CHEMETRON CORPORATION

Your letter of January 12, 1994, to Mr. David R. Sargent forwarded the NRC's comments on our "Site Remediation Plan - Harvard and Bert Avenue Sites" Revision 0, dated October, 1993. These comments supplemented the comments transmitted with your letter of December 23, 1993.

NRC COMMENTS ON SAR AND DOSE ASSESSMENT

Attachment 1
Exposure Pathways

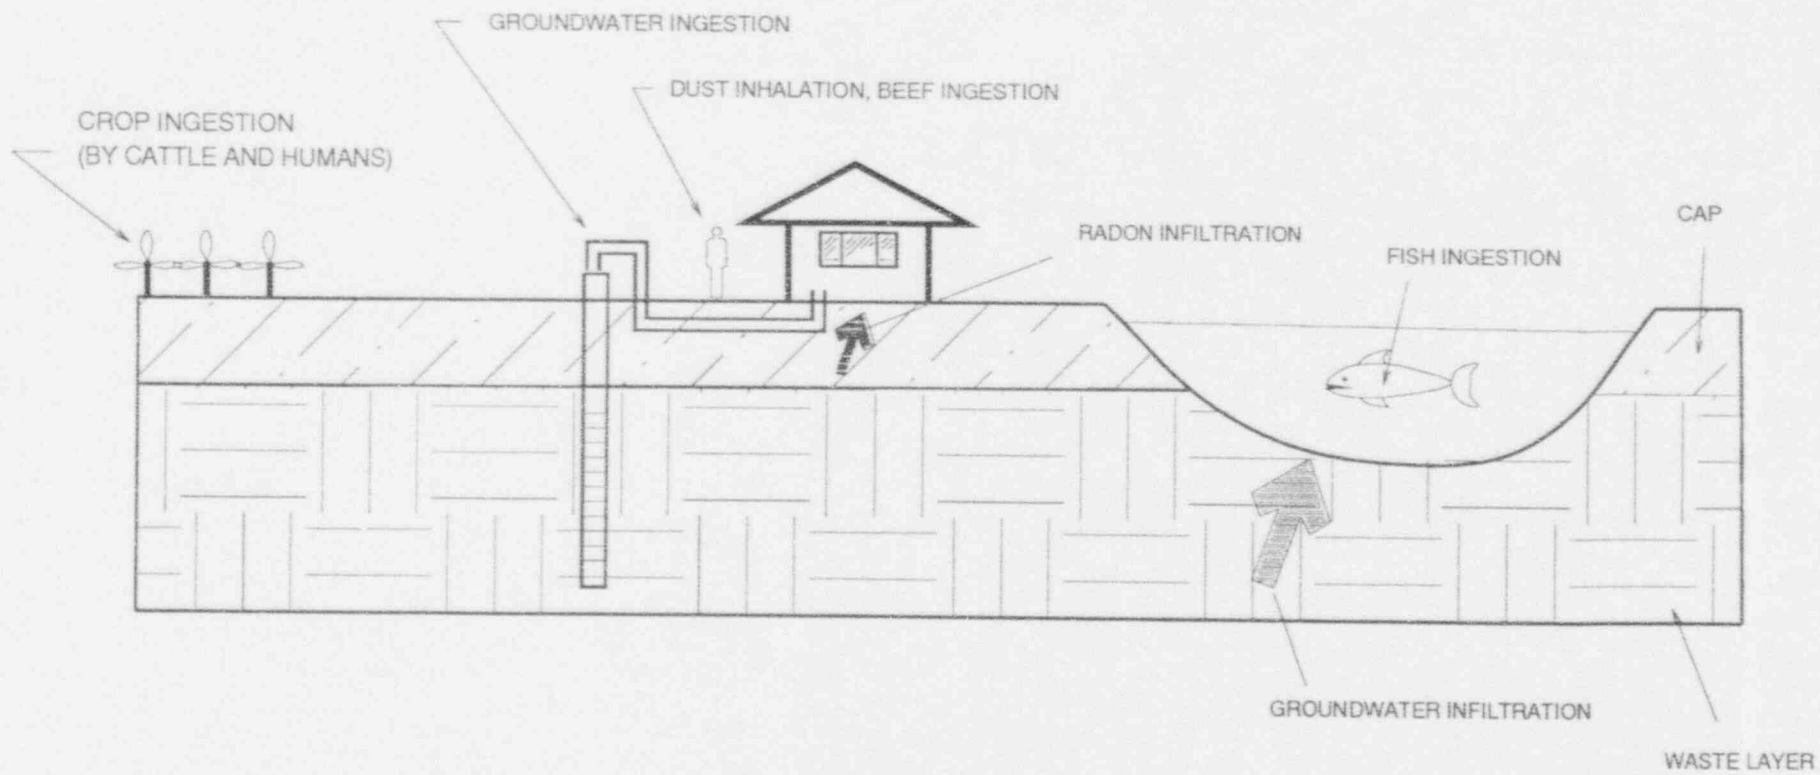
Provide a conceptual sketch of the exposure pathways used in the dose assessment.

A sketch of the exposure pathways is included as Attachment 1.
